AFRICAN DESTINATIONS NEW OFFICE INTERIORS

RENDER DOCUMENT

Rev 3
04 11 2024

BY ACO.\RCH

GROUND FLOOR RECEPTION

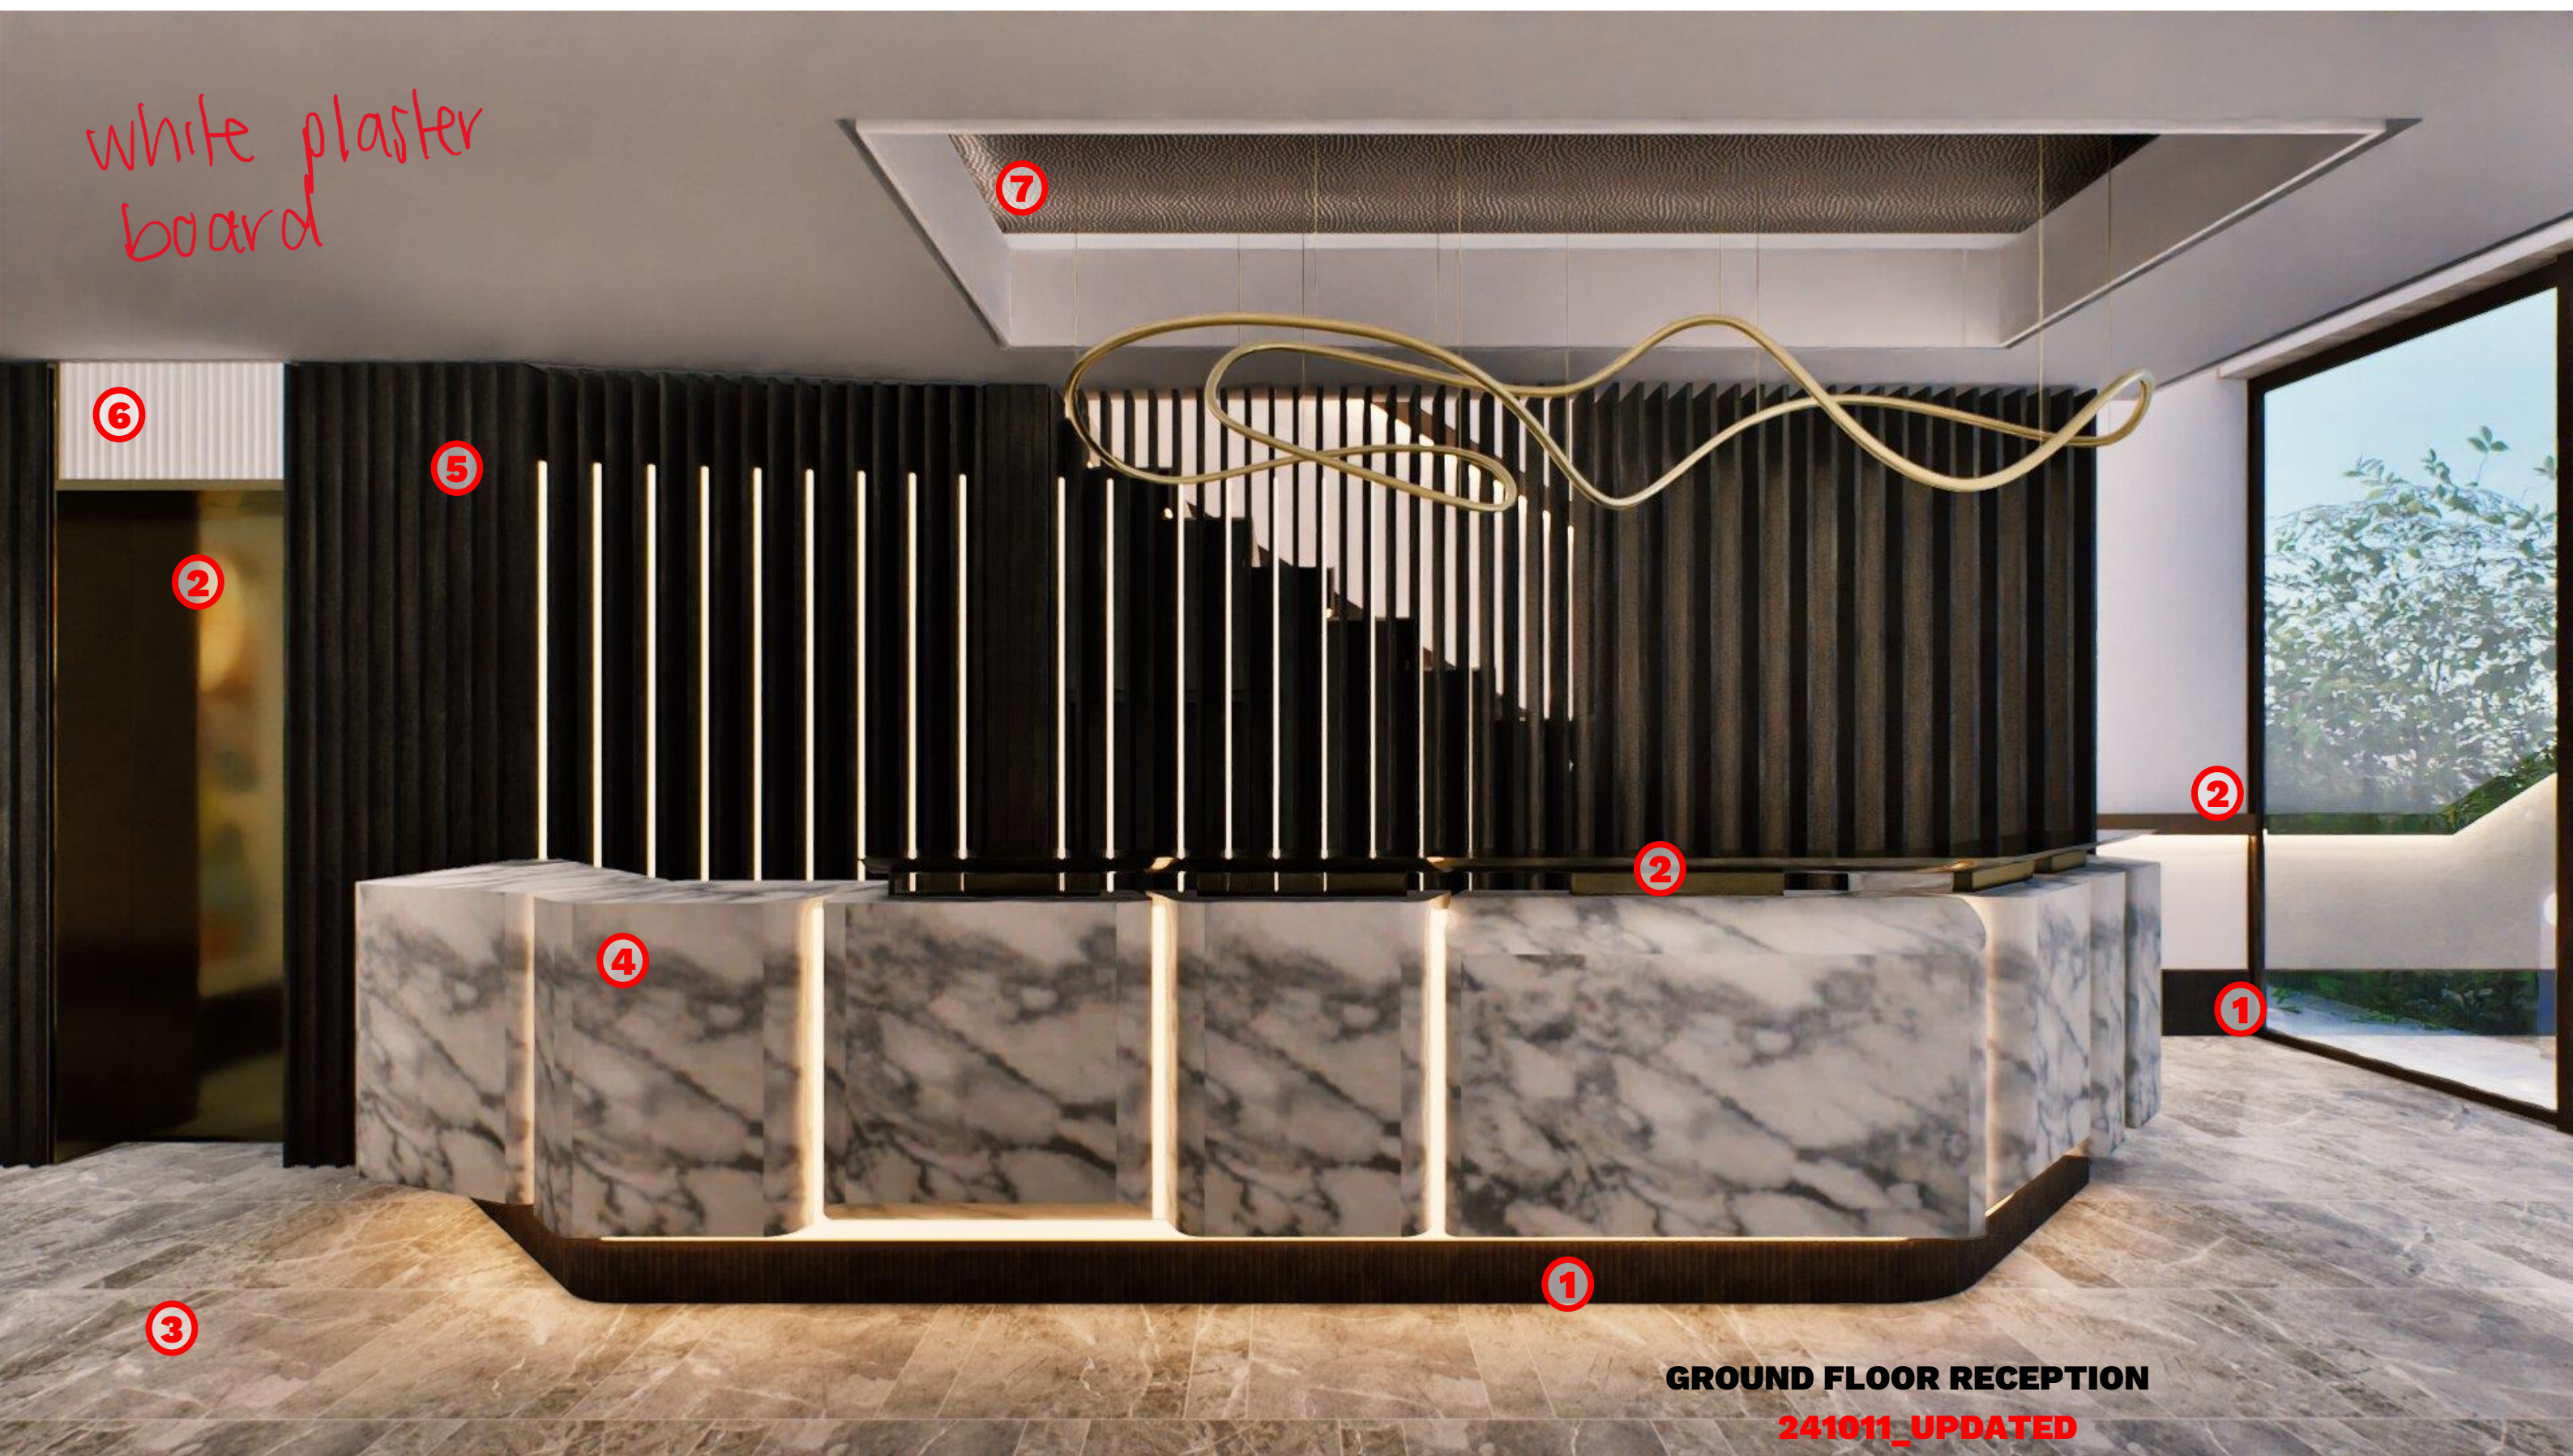
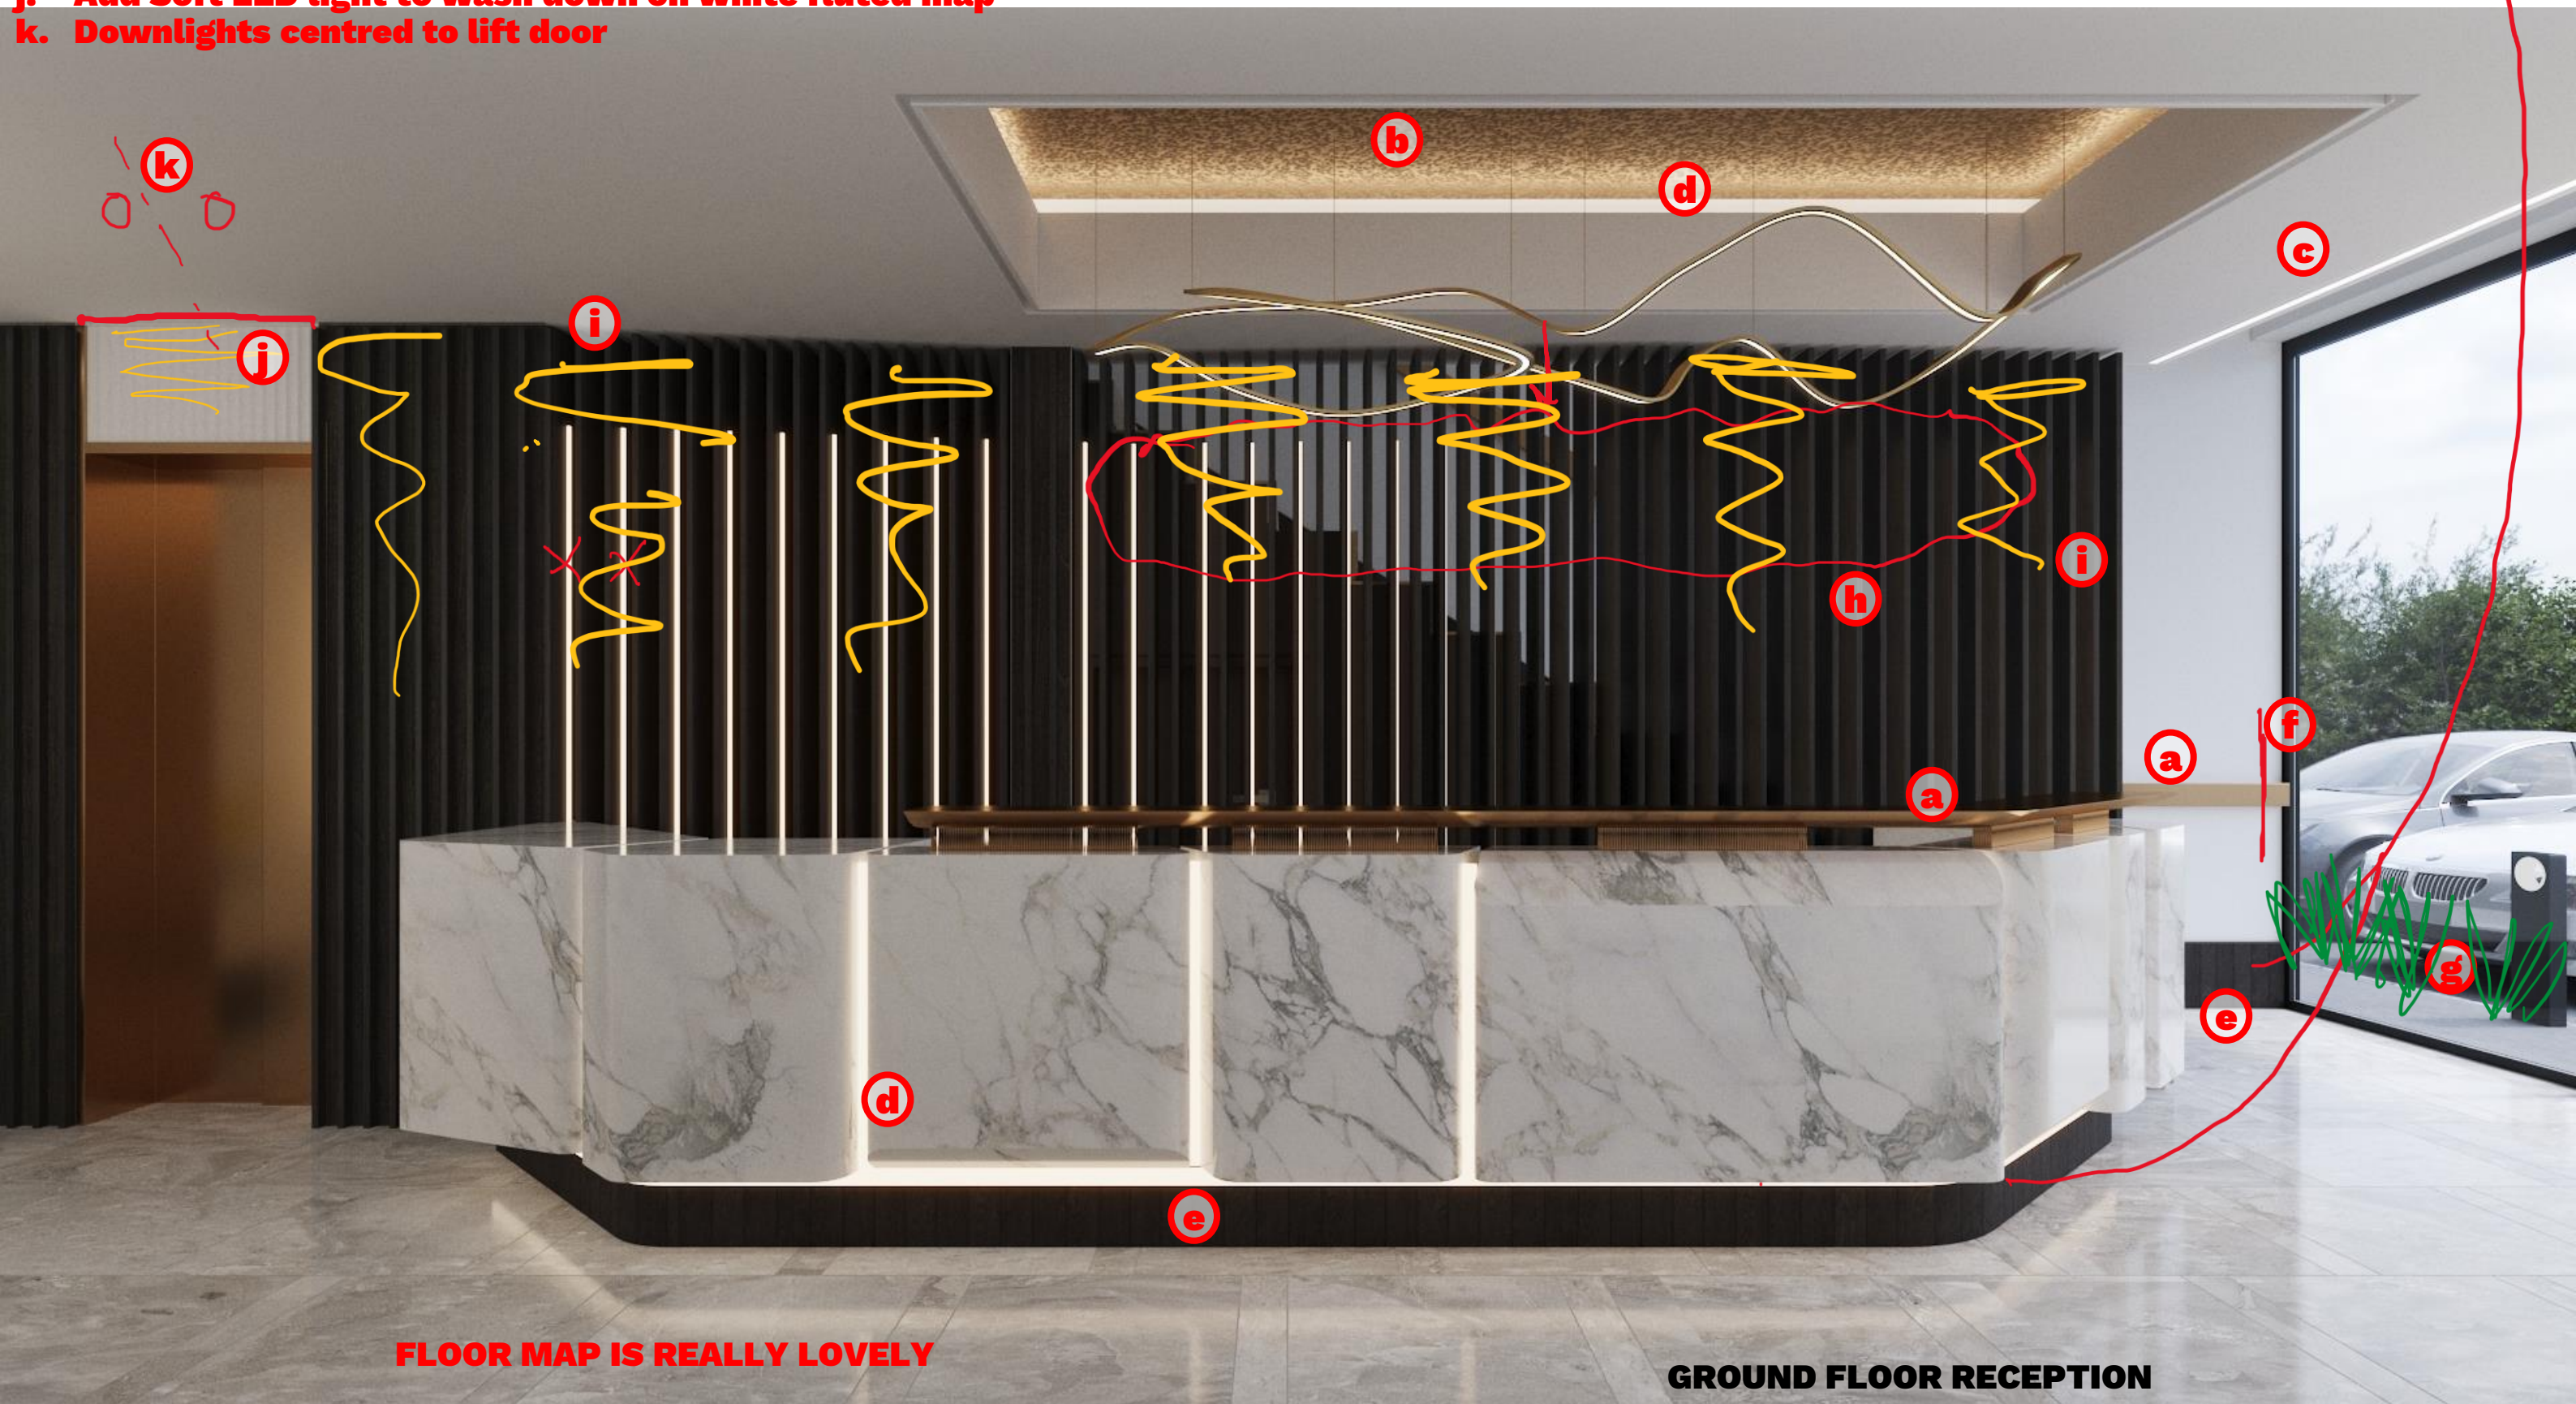
- a. Material to be less gold and more bronze
- b. Bush hammer texture not quite right, map seems dirty and too gold
- c. No LED in this recess
- d. All LEDs to have less of a harsh straight line to them, softer emitting glow – MUSTNT SEE LIGHT SOURCE
- e. Timber fluted skirting is very dark- Texture and map incorrect – see 01 on previous slide
- f. Cut back railing 100mm if possible
- g. Add some planters
- h. Drop feature chandelier as shown
- i. Remove LED Strips in screen, wash light down as shown by yellow scribbles
- j. Add Soft LED light to wash down on white fluted map
- k. Downlights centred to lift door

- a. Scale map by down 50% - needs to be smaller. Also a touch too light now.
- b. Add a soft timber oak map to the wall behind stair.
- c. Can we add a person? Preferably a Muslim lady (no full burkha though)
- d. This element behind screen looks too prominent- perhaps we can hide with maps better
- e. Timber screen texture has gone a bit grey and dull? Preferred the previous draft
- f. Perhaps we need some lights washing down between some the slats as well? But not as pronounced as previous draft.

Screen needs to feel evenly lit up.

- g. Downlights need to be centered to lift door and 200mm apart from each other- ie closer together

- h. Ceiling Recess - Glow was better in previous draft. Hide the strip light source.

- i. Gentle LED strip glow underneath brass counter

- j. Gentle LED glow missing in handrail- see our Twin Motion view

- k. Move this spotlight that highlights the column behind

- l. Recessed 50mm LED strip- mustn't see light source- to see a wash of light down fluted material

- m. White stone sculpture on desk. Must be isalmic

Friendly - no people, animals, faces etc

Overall view feels grey & dull- not sure why. Previous draft felt a lot brighter and warmer?

GROUND FLOOR RECEPTION

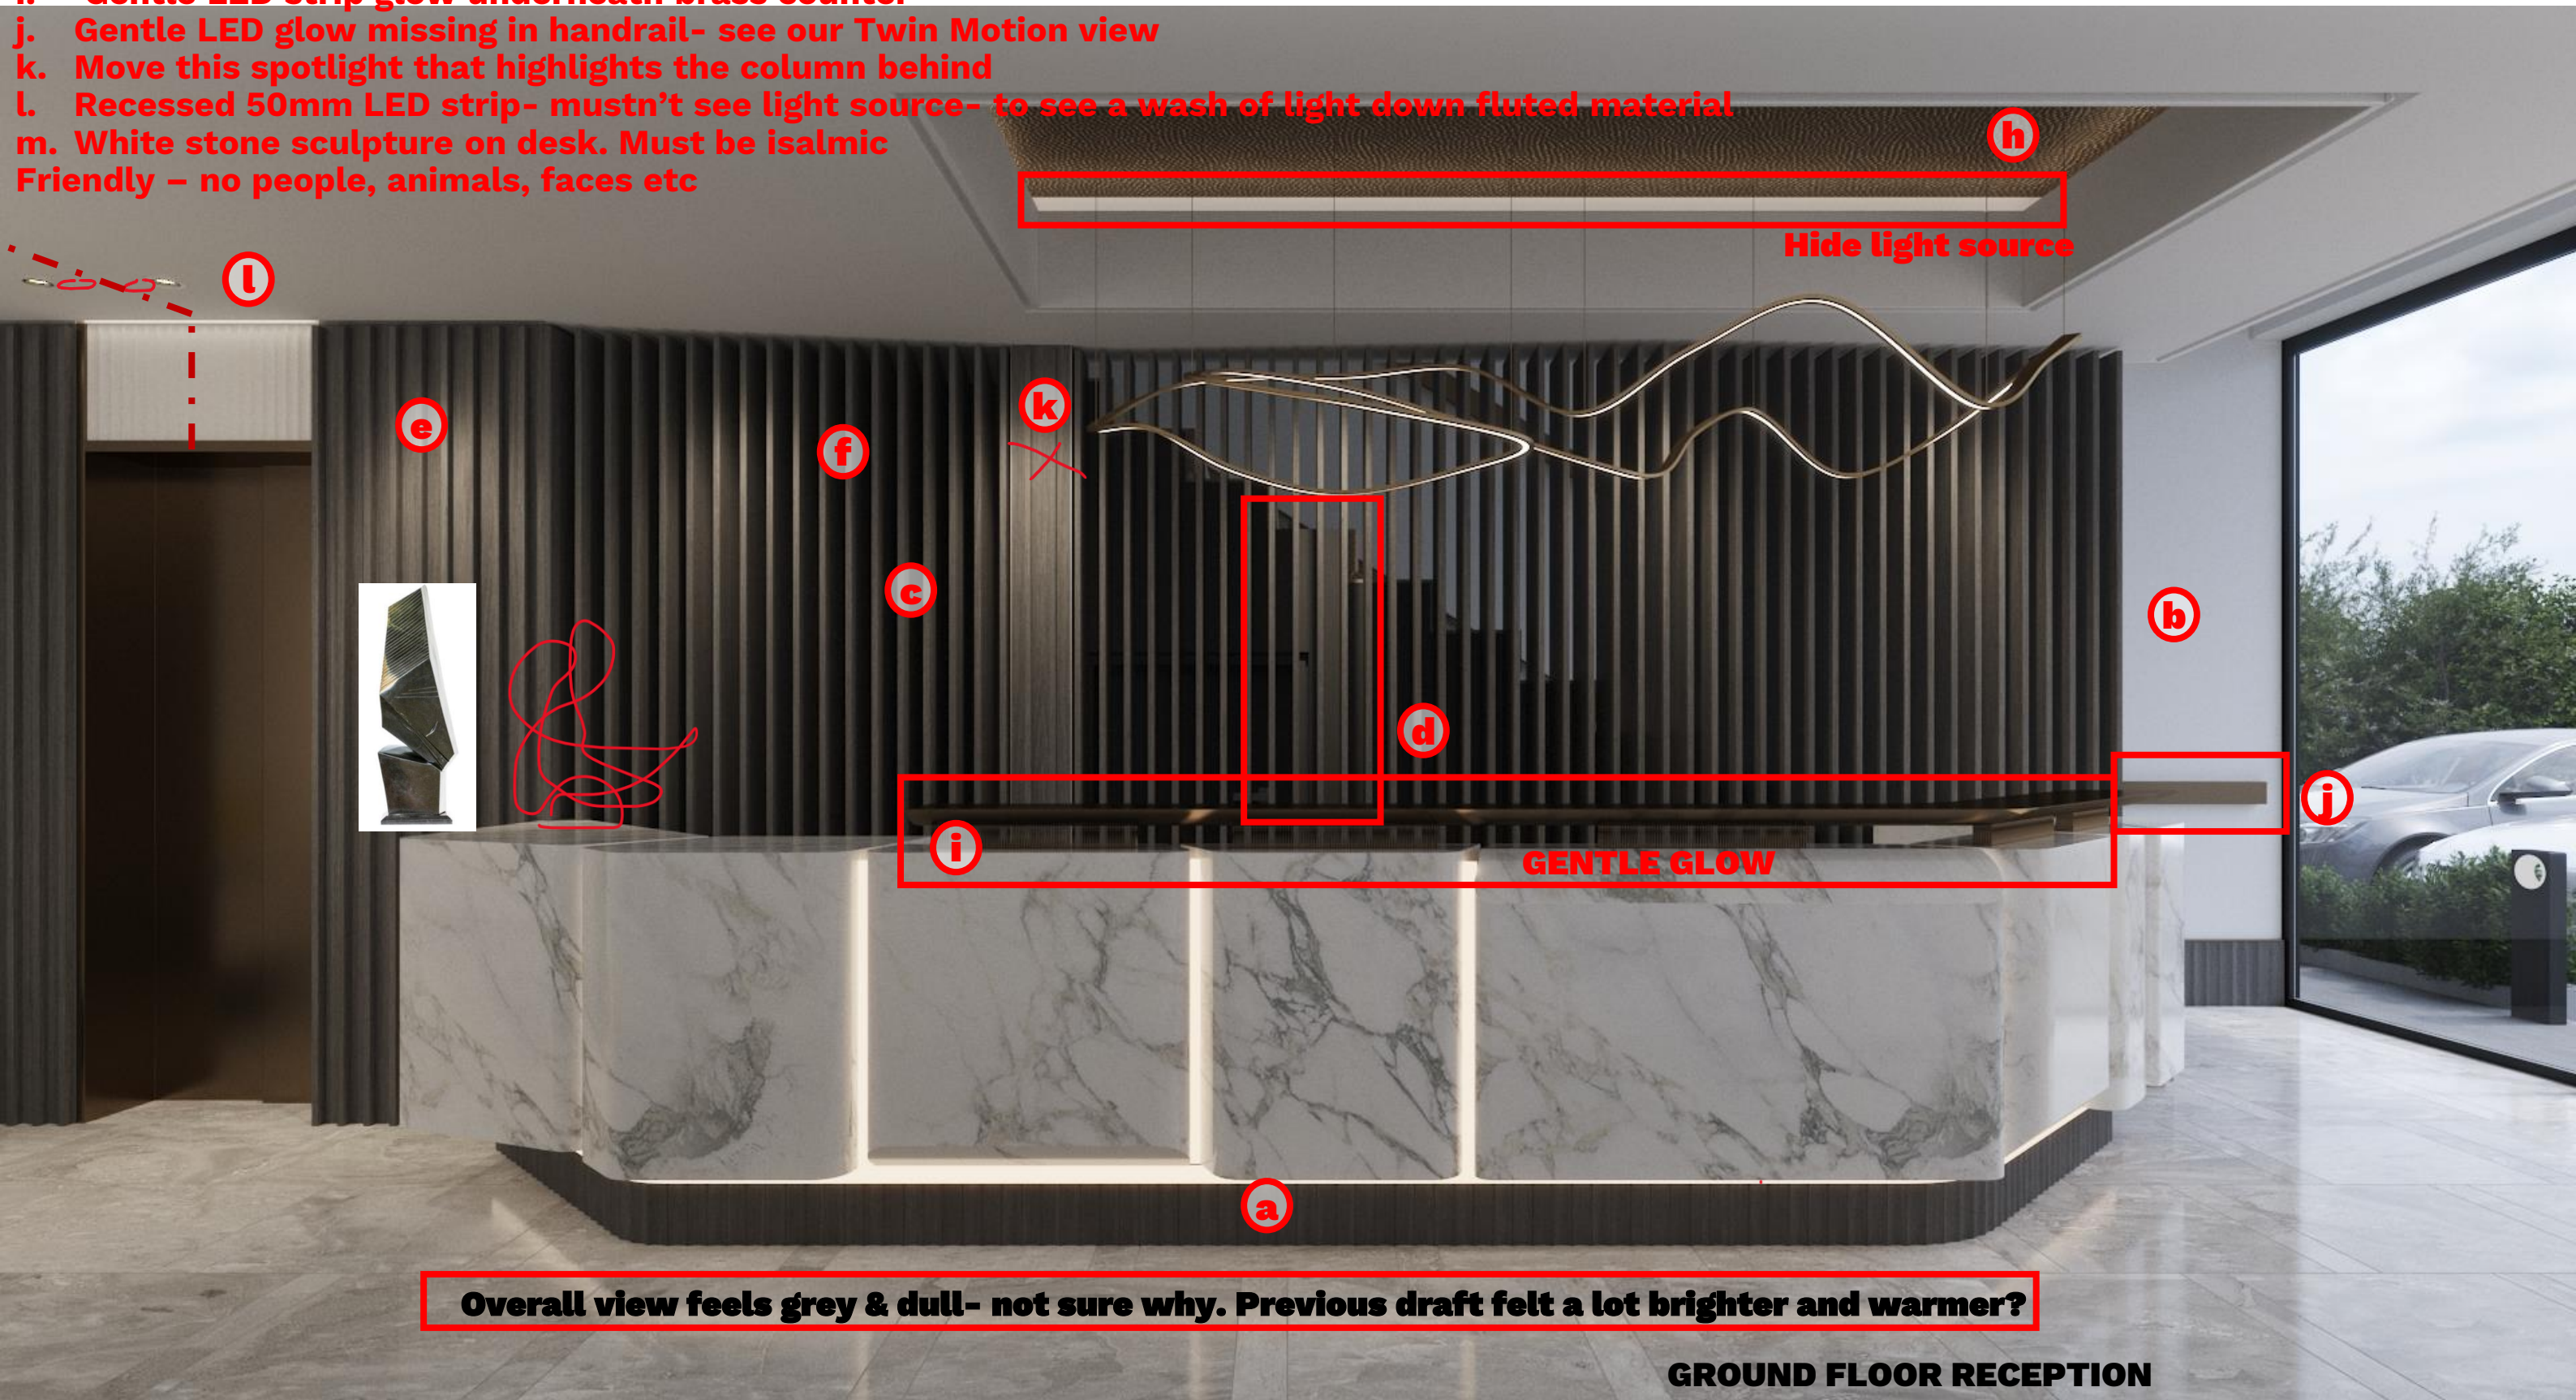
- a. Need lights washing down the screen. – doesn't look lit up much? - needs to feel like a glow of light lighting up the screen
- b. Ceiling Recess Glow- looks good but dull- could be a bit brighter. The brightness and glow from draft 01 was good.
- c. Light glow in recess needs to be a little warmer and more prominent
- d. Wrap recess
- e. Bronze trim to edge
